SPF WATER
ENGINEERING

March 4, 2012

I have read Michele Edl's February 3, 2012 memorandum regarding review of the beneficial use field report for permit 63-12593. Below are quoted sentences from that review memo followed by my response comments.

Schematic of Idanha Building Heating and Cooling System
Permit 63-12593 (not to scale)

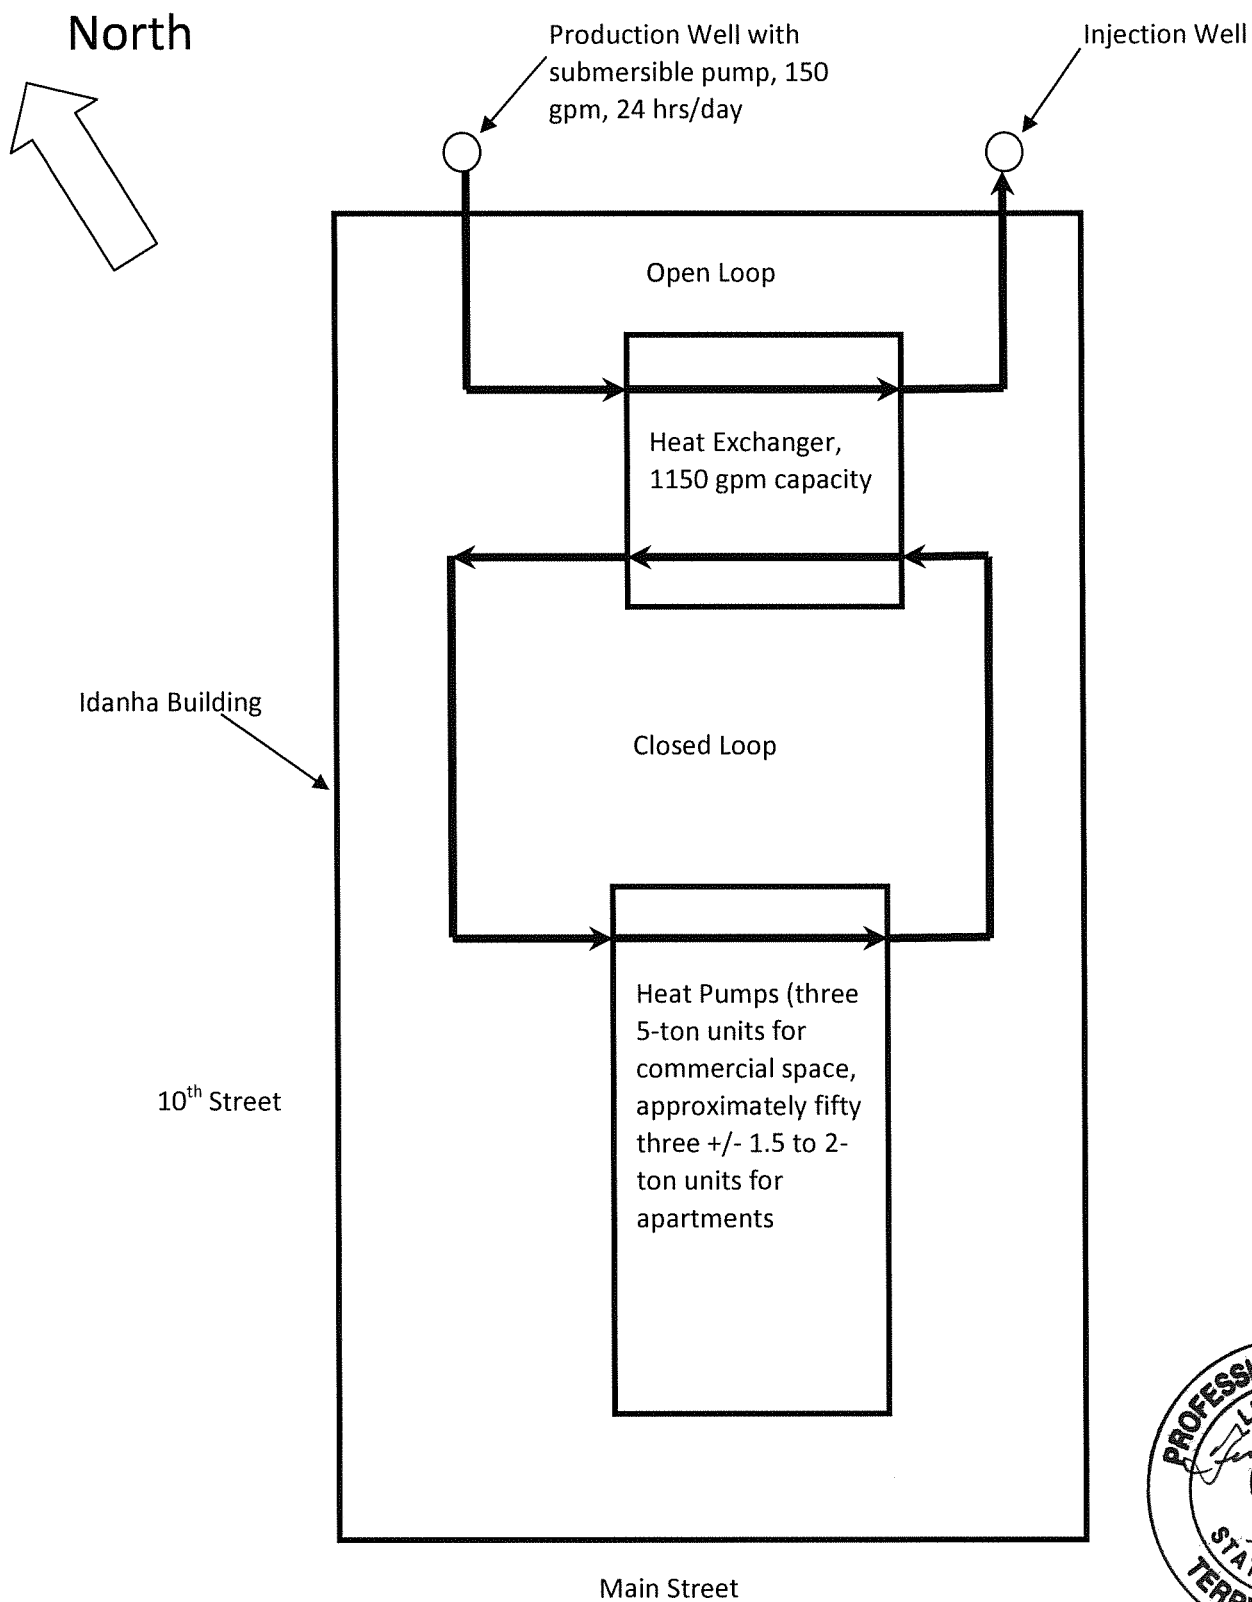
13. *The system description provided in the narrative is both lacking in detail and outside the most relevant timeframe. A detailed schematic and/or as-built drawings of the system are needed.*

Attached is a schematic.
